Project	IEEE 802.16 Broadband Wireless Access Working Group < http://ieee802.org/16 >	
Title	Enhancement for rate 1, 4-transmit antenna STC	
Date Submitted	2004-11-04	
Source(s)	Jianzhong (Charlie) Zhang, Kiran Kuchi, Anthony Reid, Nico Van Waes	Voice: 972-374-0958, 972-374-1862, Fax: 972-894-5937 charlie.zhang@nokia.com , kiran.kuchi@nokia.com
	Nokia 6000 Connection Drive Irving, TX 75039	
Re:	IEEE 802.16e D4 Draft	
Abstract	Proposes an enhancement to rate 1, 4-transmit antenna space time code	
Purpose	To incorporate the changes proposed here into the 802.16e D5 Draft.	
Notice	This document has been prepared to assist IEEE 802.16. It is offered as a basis for discussion and is not binding on the contributing individual(s) or organization(s). The material in this document is subject to change in form and content after further study. The contributor(s) reserve(s) the right to add, amend or withdraw material contained herein.

Enhancement for rate 1, 4 transmit antenna STC

Jianzhong (Charlie) Zhang, Kiran Kuchi, Tony Reid, Nico Van Waes
Nokia

Figure1: FER performance of rate 1, circulated matrix A

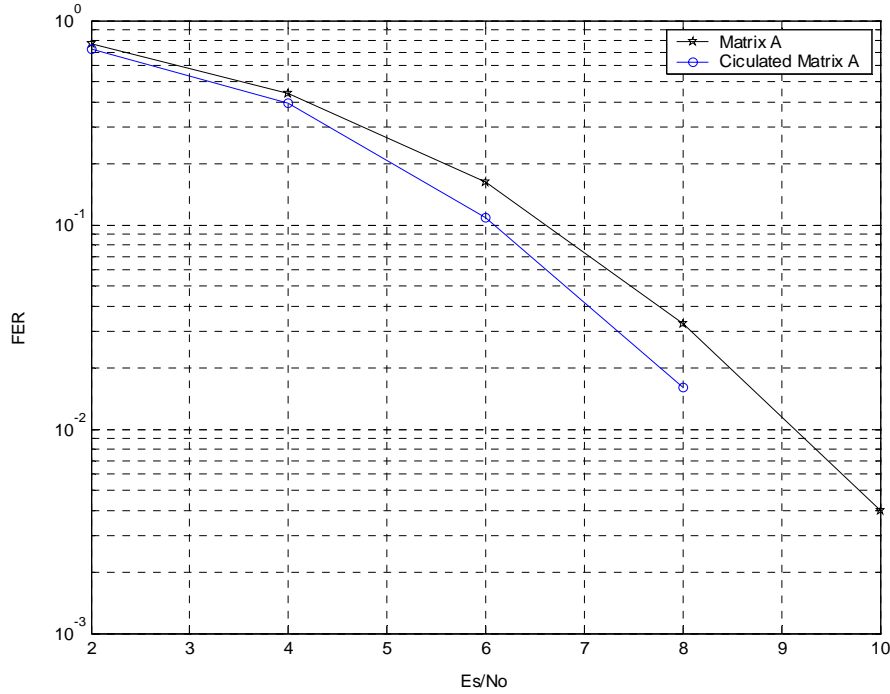
In Figure 1, we compared the FER performance of the circulated code to Matrix A for 4 Tx and 1 Rx case in for Ped B channel, rate 1/2 convolutional code, QPSK modulation. We notice a coding gain of up to 0.7 dB. Similar gains are observed for other modulation and coding modes.
